Urgent Field Safety Notice
Product Correction
Urgent - Immediate Action Required

March 7, 2019

Product Name	List Number	Serial Number	UDI
Alinity ci-series System Control Module (SCM)	03R70-01	All	N/A
Level Sensor, Bulk Solution	04S68-01	All	N/A
Accessory kit, Alinity i	03R66-01, 03R66-02	All	N/A
Accessory kit #2, Alinity c	03R69-01, 03R69-02	All	N/A

Alinity ci-series issues resolved in software version 2.6.0

Figure 1. Level Sensor, Bulk Solution identification label

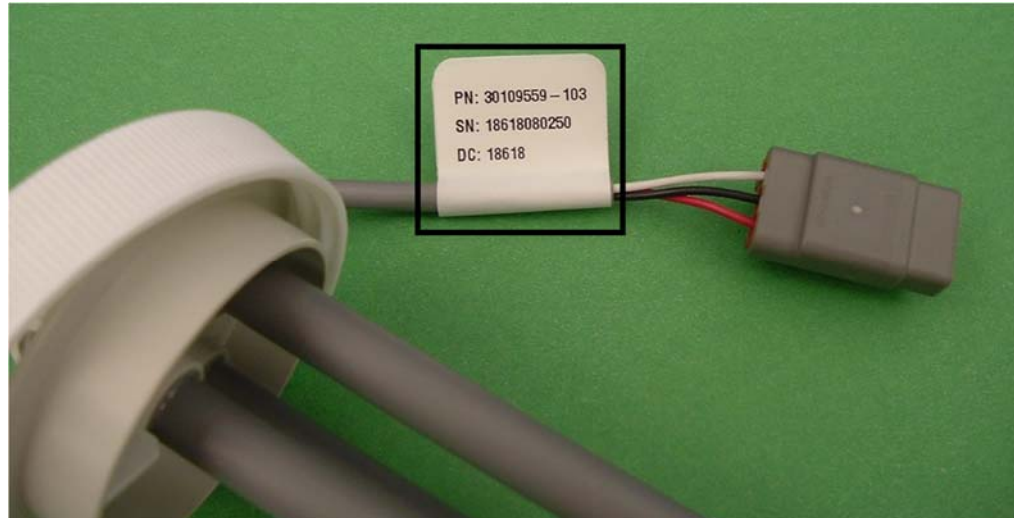
- If the part is in the box, the list number (04S68-01 or 04S68-02) is printed on the label
- If the part is removed from the box or installed on the Alinity ci series, the part number is printed on a label attached to the electrical connection for the part. See Figure 1 and Table 1 below.

List Number (LN)	Part Number (PN)	Instructions
04S68-01	30109559-102	Remove and replace any Level Sensor, Bulk Solution, LN 04S68-
04S68-02	30109559-103	01/PN 30109559-102 with LN 04S68-02/PN 30109559-103
